CRP consortium meeting: 5/05/2021

- General news:
- Anode PCB adapter boards status
- CRP composite frame status for first CRP colbox

- Report drafted by the committee and available on edms (27/04/21):
 - <https://edms.cern.ch/document/2565930/1>
- Several recommendations are given for all the following aspects:
 - Anodes
 - Mechanical Support Design
 - CRP factories
 - Electronic interfaces
 - Prototyping plans

4 Mechanical Support Design

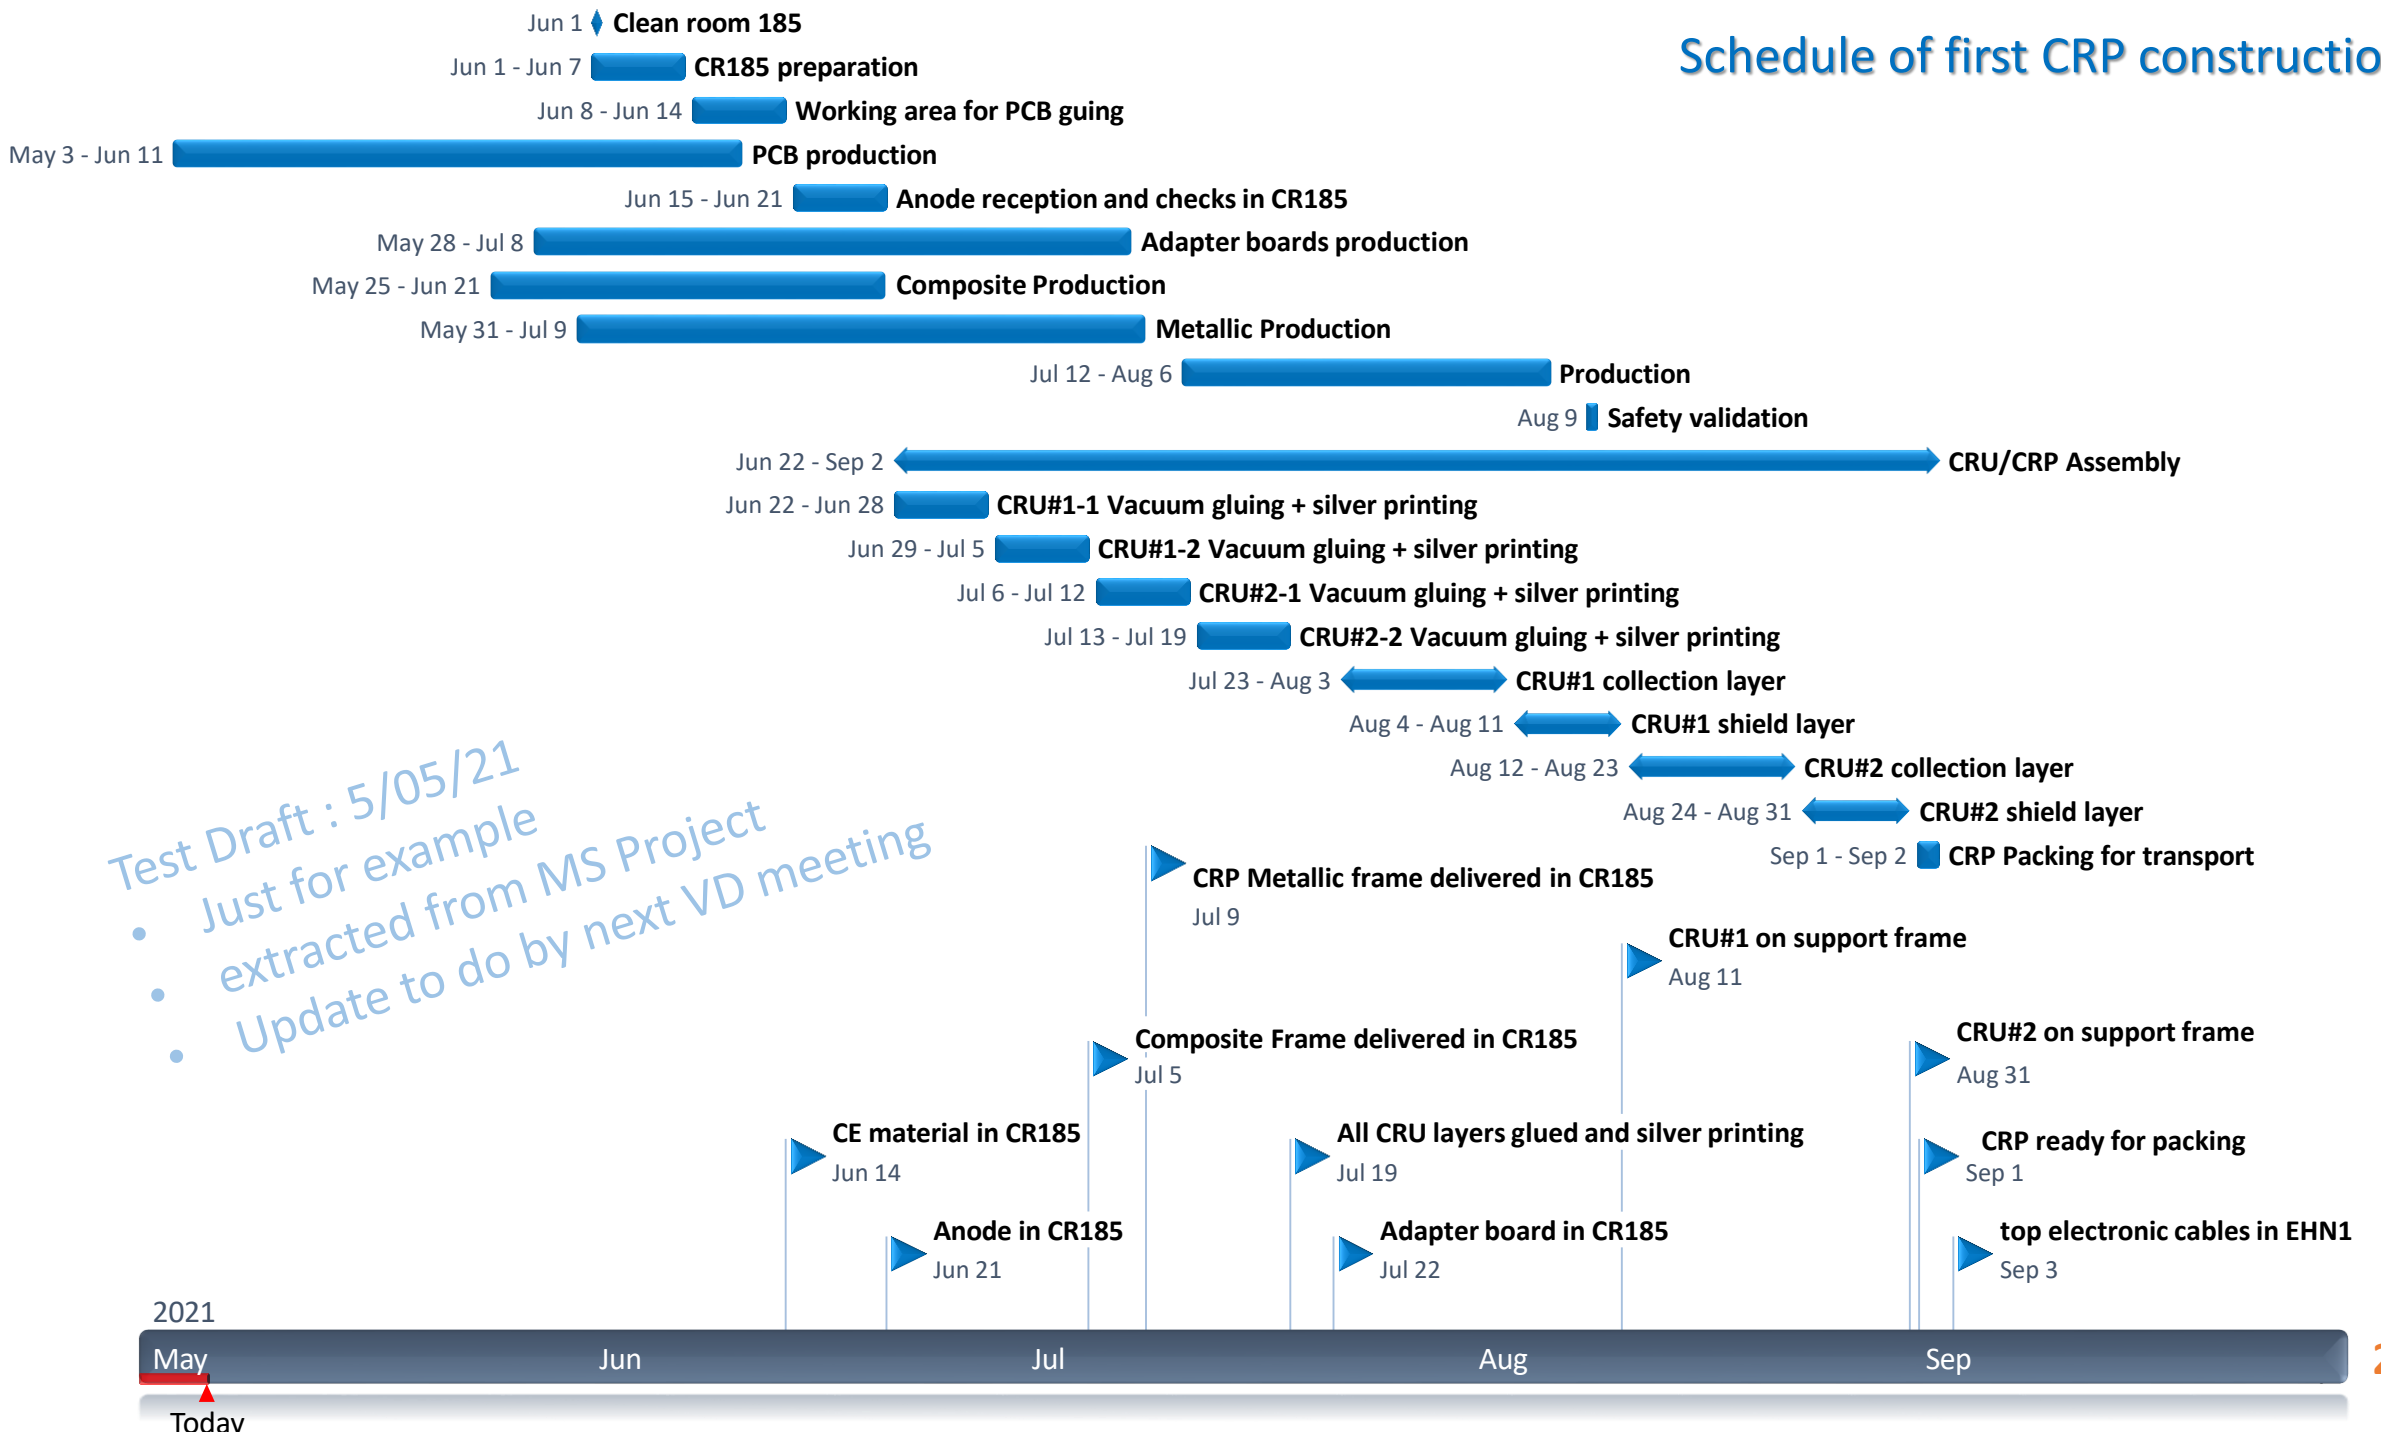
- All materials should be validated in the MTS for compatibility with LAr.
- Consider a design to allow for more variation at warm as long as it meets specs in LAr.
- The team presented very detailed and good CRP assembly steps. Is there possibility to simplify these steps?

- Further investigate the mechanical support with an eye to optimize transparency and impact on overall planarity. Support structures should be easy to disassemble and reassemble for transport.
- Consider mechanical support for the half-size CRP option.
- All materials should be validated in the Material Test Stand for compatibility with LAr.
- Consider a design that allows for more variation at warm as long as it meets specs in LAr.
- More details are needed describing the principles of the mechanical support of structure to anode. Please document the risks of damage to anode during assembly or transport?
- Provide initial plans and sketches of the CRP transport box.
